APPLICATION FOR A SPECIAL USE PERMIT

APPLICATION #: SUP25-0037
APPLICANT: I.B.B. Prestige Inc.
OWNER: I.B.B. Prestige Inc
ADDRESS: 2485 N. Detroit Avenue
PARCEL(S): 09-64564, 09-64561, 09-64557, & 09-64551
ZONING: Regional Commercial (CR)
NEIGHBORHOOD: Overland
REPORT DATE: July 31, 2026
HEARING DATE: August 13, 2026
STAFF REVIEWER: Schultz

Proposed Site Plan

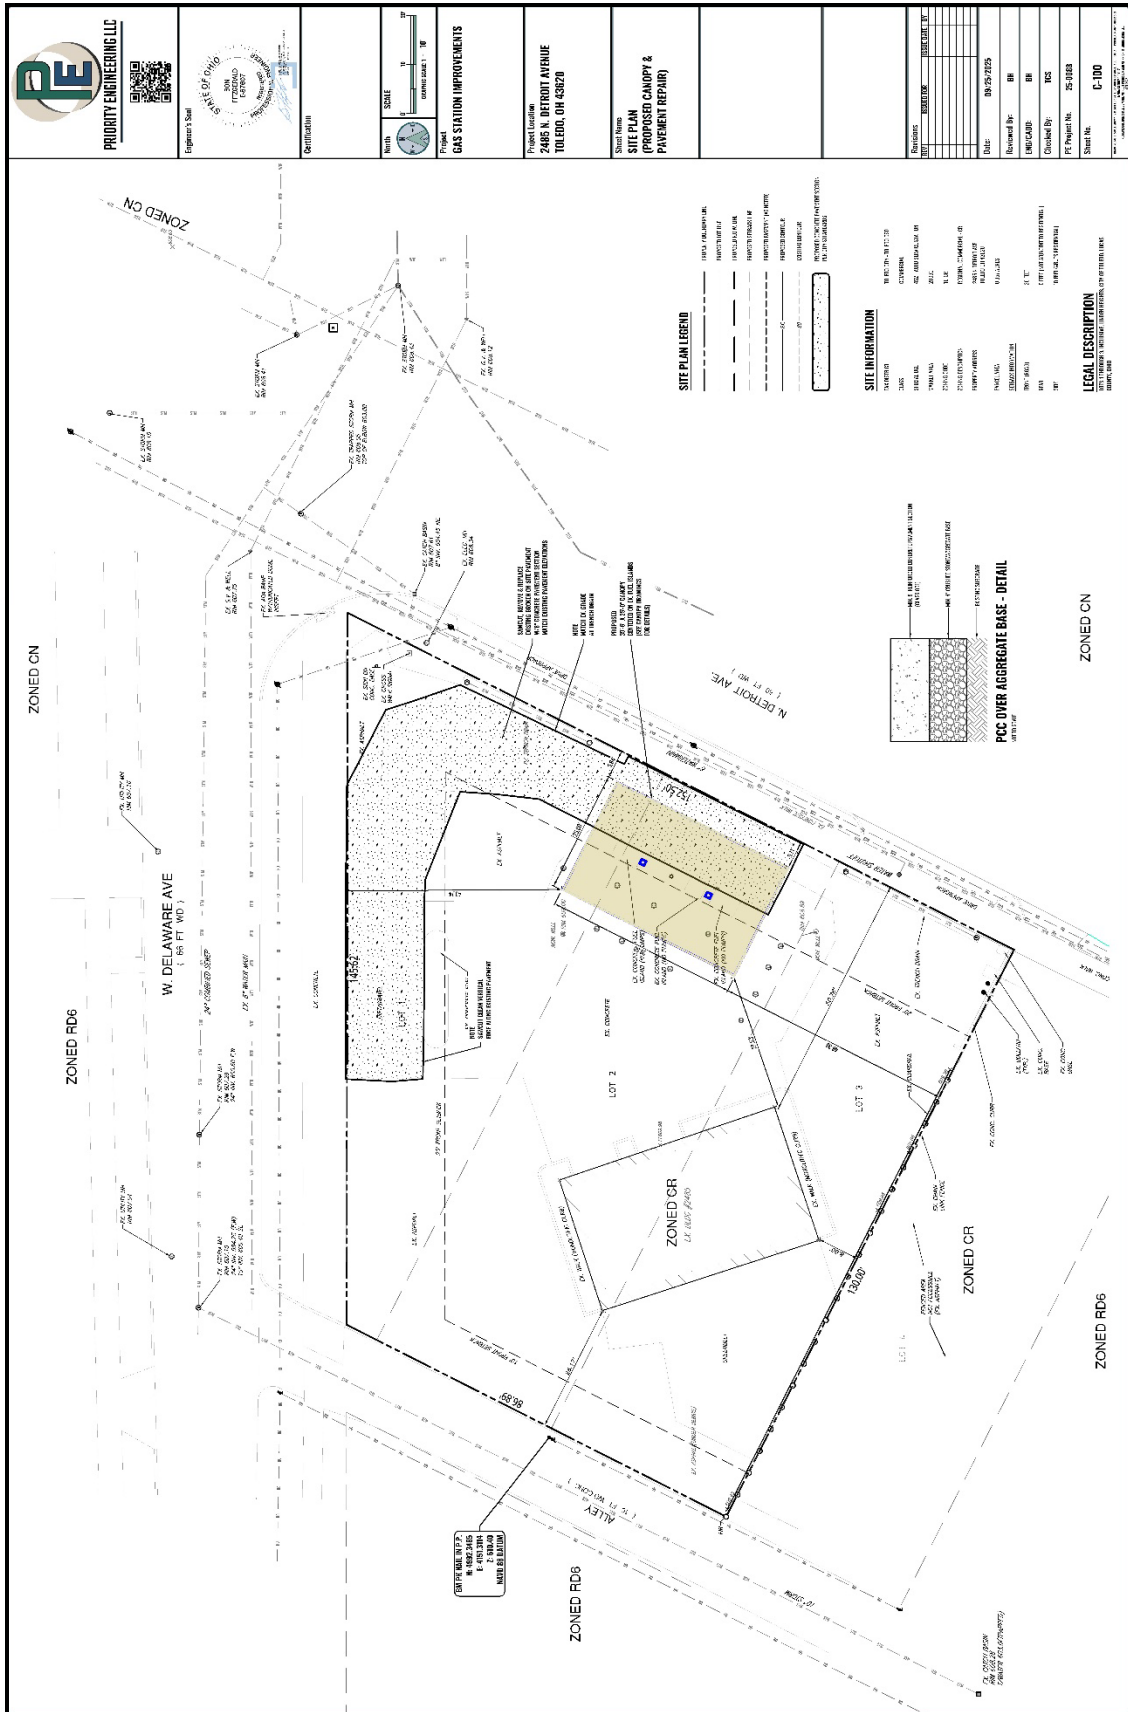
- (a) *Gasoline and Fuel Sales, Review Items (1104.0901)*. The intensity, location, and screening of proposed outside lighting, including canopies, should be reviewed as part of any proposed gas station. The hours of operation may be limited to reduce detriment to the area. – The applicant shall submit a lighting plan ensuring all lighting is selected and arranged to direct and reflect light away from any adjacent residential property or public right-of-way. The hours of operation shall also be limited from 5:30 a.m. to 1 a.m.

- (b) *Gasoline and Fuel Sales, General Requirements (1104.0903)*. Canopies shall be set back a minimum of 10 feet from the property line, and shall be designed to be consistent with the building materials and colors of the principal building. Support columns shall be brick, brick base, or other durable materials compatible with the principal building. – Canopy location is acceptable as depicted. Canopy elevations shall be provided ensuring its design is consistent with this section.

- (a) *Vehicle Stacking Areas (1107.1600)*. A minimum of one (1) vehicle stacking space is required for each gasoline pump island. Such spaces shall be a minimum of ten feet (10') by twenty feet (20'). – See Traffic Management conditions. All gas pumps must be clearly shown and noted where a blank side of a pump is going to be on a revised site plan.
- (b) *Accessible Parking (1107.1700)*. A minimum of one (1) van-accessible parking space is required. – Number, location, and signage is acceptable as depicted. An accessible ramp is required for the existing raised sidewalk around the building to the accessible entrance.
- (c) *Wheel Stops (1107.1907)*. Wheel stops are required whenever a parking lot extends to a property line, sidewalk, planting strip, or building. – Shall be shown on a revised site plan.

- (a) *Applicability (1108.0102)*. While the proposed project does not result in an increase in building area or the size of an off-street parking area, it does somewhat change the premises. The applicant has therefore proposed a forty-two-inch (42") high decorative fence along W Delaware Avenue and some planter boxes along the edge of the existing building. Adjustments to the proposed planter box locations must be made to ensure adequate ADA accessibility. A revised landscape plan shall be submitted. This is otherwise acceptable.
- (b) *Dumpster/Trash Receptacle Screening (1108.0203(G))*. All four sides of the dumpster must be screened at a minimum height of six feet (6'). Screen materials can be any combination of evergreen plantings, fence or wall structure. – Acceptable as depicted.

5. Trace out any drainage pipes on site, notably from the ex. Trench drain on the site plan to its connection to a city basin or city pipe. Add the information to the site plan and provide revised drawing to Andy.Stepnick@toledo.oh.gov. 419-245-1338.

19. 10' x 20' vehicle stacking must be shown correctly at each pump being utilized per TMC 1107.1602.
20. Wheel stops are required at all parking spaces abutting property lines, planning strips and buildings per TMC 1107.1907.
21. A 25' drive aisle is required for two-way traffic measured from vehicle stacking to Building sidewalk per TMC 1107.1911.
22. All driveways, drive aisles and vehicle stacking must be clearly shown and dimensioned per TMC 1107.1911.
23. All gas pumps must be clearly shown and noted where a blank side of a pump is going to be on the drawings.
24. An accessible sidewalk ramp is be required for the existing raised sidewalk around the building to the accessible entrance per ADA (Americans with Disabilities Act).

29. The applicant shall submit a revised site plan to the Plan Director with bicycle parking details showing compliance with TMC§1107.0902.
30. The applicant shall submit a revised site and/or landscape plan to the Plan Director ensuring an accessible route exists from the accessible parking spot to the building's main entrance without planter boxes in the way.
